Input Data

Plan Amendment

Figure 1: Added lanes between version 8.3 and 8.3.1.

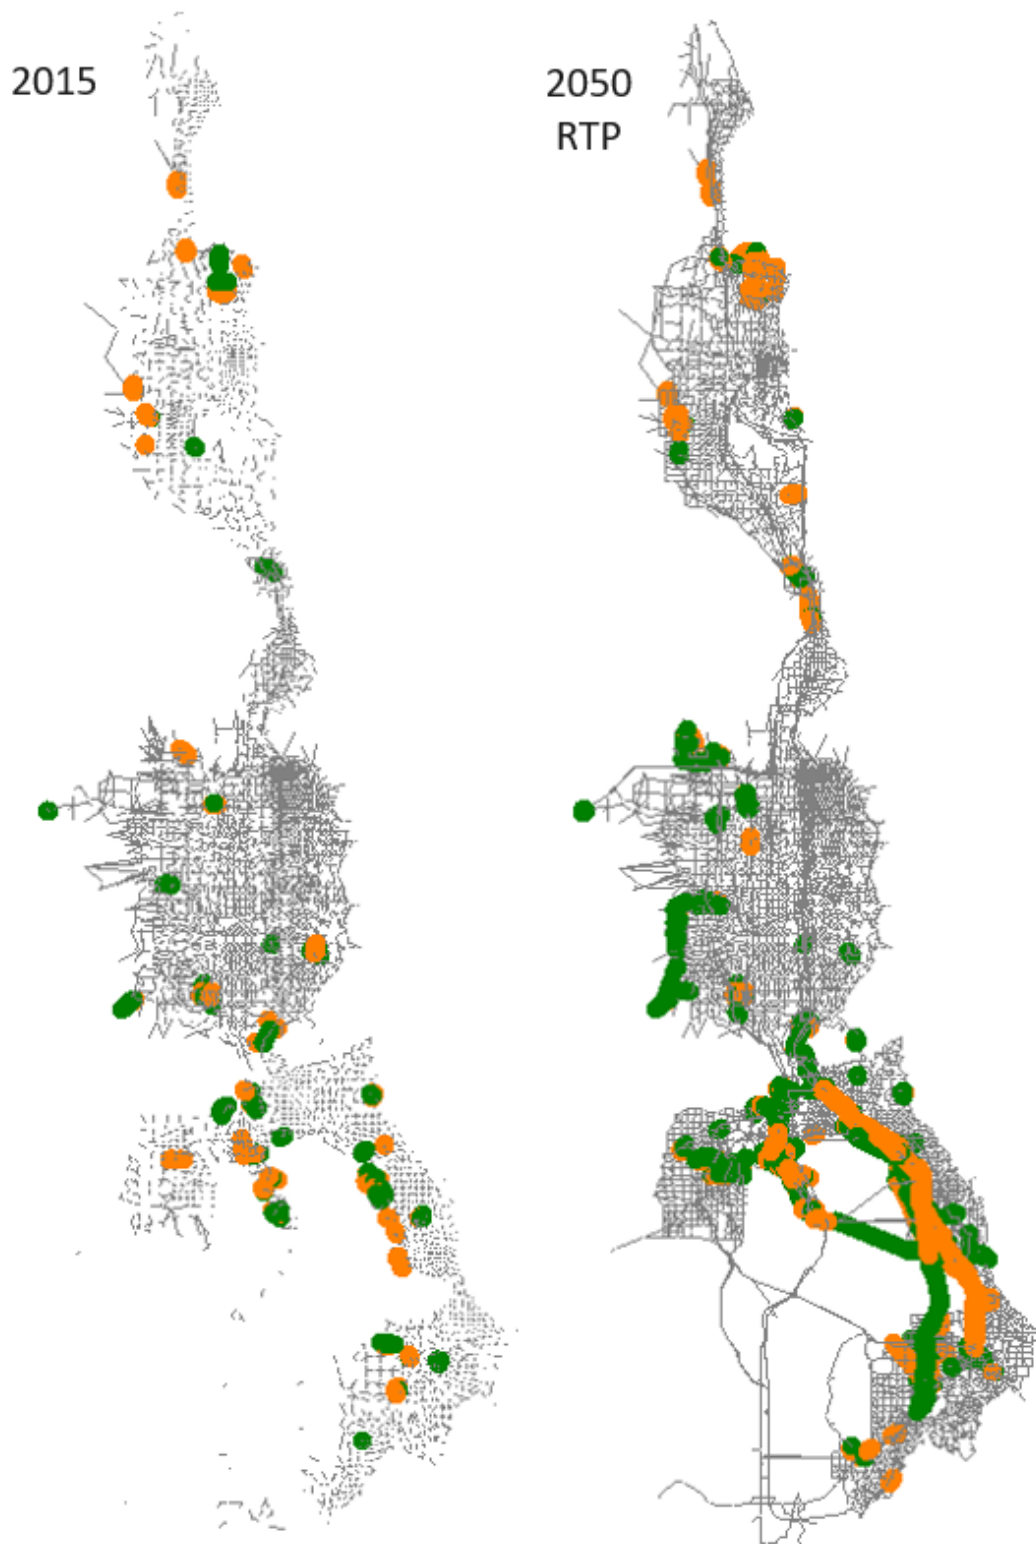
The highway network was updated in the MAG and WFRC areas to reflect the first round of Regional Transportation Plan (RTP) amendments. Additional edits were made in the MAG area to conform with more recent project clarification. The changes to the input highway network are significant, particularly in Utah County, and would most likely affect the travel model's output. Projects in and around areas of high change may want to do sensitivity tests to better understand the impact that these input network changes may have had on project-level decisions. Figure 1 shows where lanes were added (green) or were taken away (orange) between versions 8.3 and 8.3.1 highway networks.

Figure 1: SR 201 connection externals.

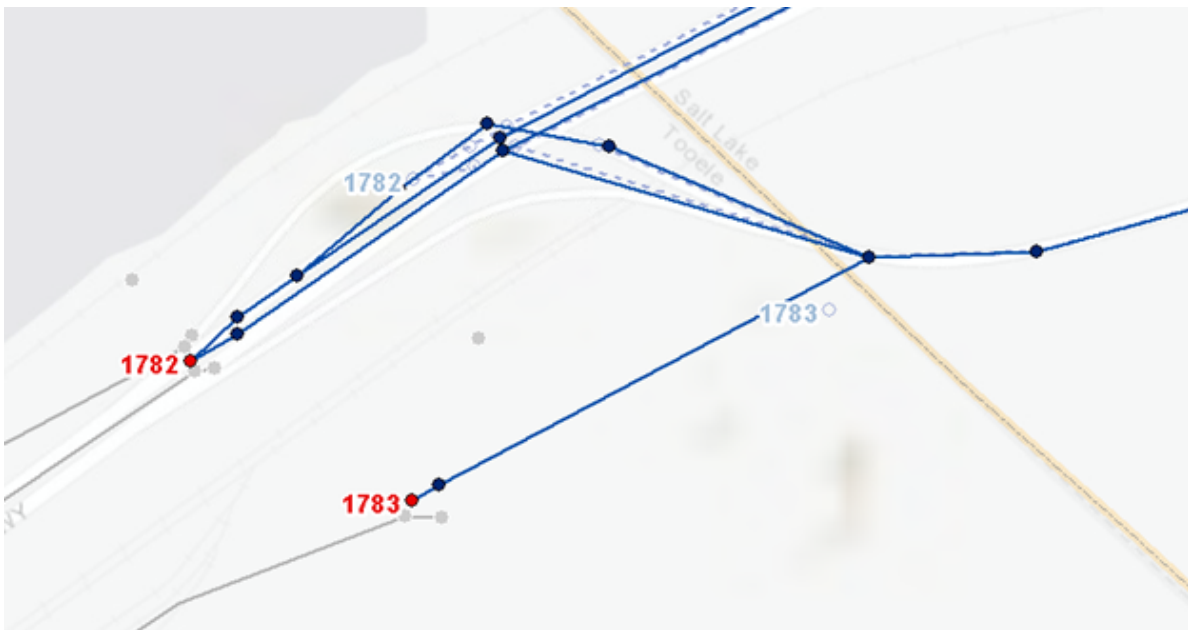
The highway network was modified at the Salt Lake, Tooele County boundary to provide an independent connection to SR 201 at external 1783. (Note external 1783 existed in the version 8.3 network as a place holder and was not connected to the network in that version.) Externals 1782 and 1783 were moved to improve the connection between the Wasatch Front and USTM travel models. The connecting highway links were also modified to accommodate this change.

External 1783 is connected to the highway network via a high-speed divided highway (FT=14) beginning in the 2030 fiscally-constrained plan year. In this year, external volume forecasts also begin for external 1783. Prior to 2030, external 1783 is unconnected to the scenario network and the external volume is zero.

Figure 2: Average weekday traffic volumes for externals 1782 and 1783.

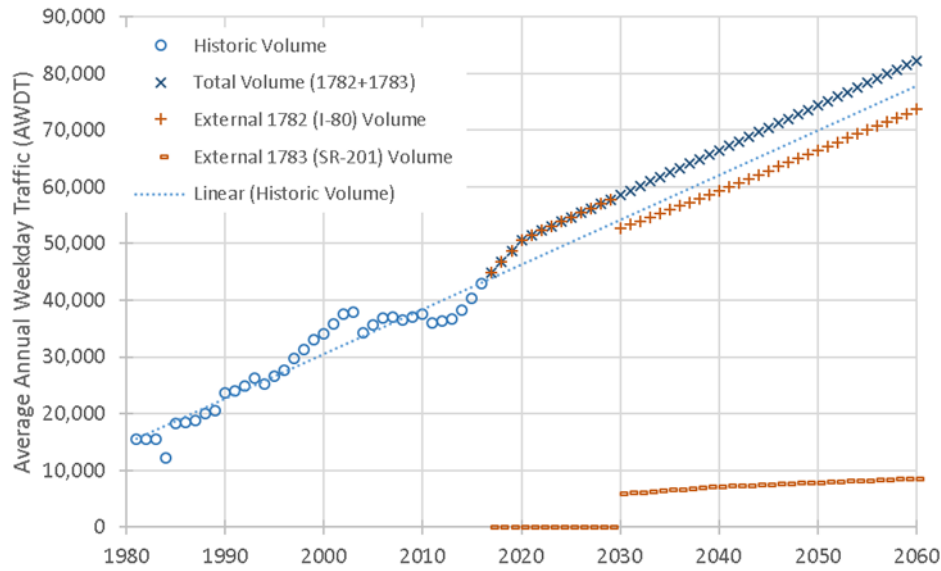
The external volume source file and model input files, '_Source_ExternalTAZ_HistoricalAADT - 2020-04-30.xlsx' and 'external_year_vol.csv' found in '1_Inputs\5_External Ext_Vol_Control', were updated to reflect the changes in externals 1782 and 1783. The forecast annual average daily traffic (AADT) for external 1782 was carried forward from version 8.3. The version

8.3 volume was then divided between the two externals based on information from the Utah Statewide Travel Model (USTM) and professional judgement. The average weekday, single-unit and combo-unit factors for external 1782 were brought up to date with the most current information from the master segment shapefile in the model input folder:

- Average Weekday Factor = 1.057 (was 0.980)
- Single-unit Truck Factor = 7.6% (13%)
- Combo-unit Truck Factor = 9.8% (was 10%)

While the forecast AADT is identical to version 8.3, the change in weekday factor increased the input volume into the Wasatch Front model space by roughly 6%. The relative share of these trips also changed with significantly fewer medium trucks and more passenger cars. The share of heavy trucks stayed about the same. The weekday and truck factors for external 1783 were set to be equal to external 1782.
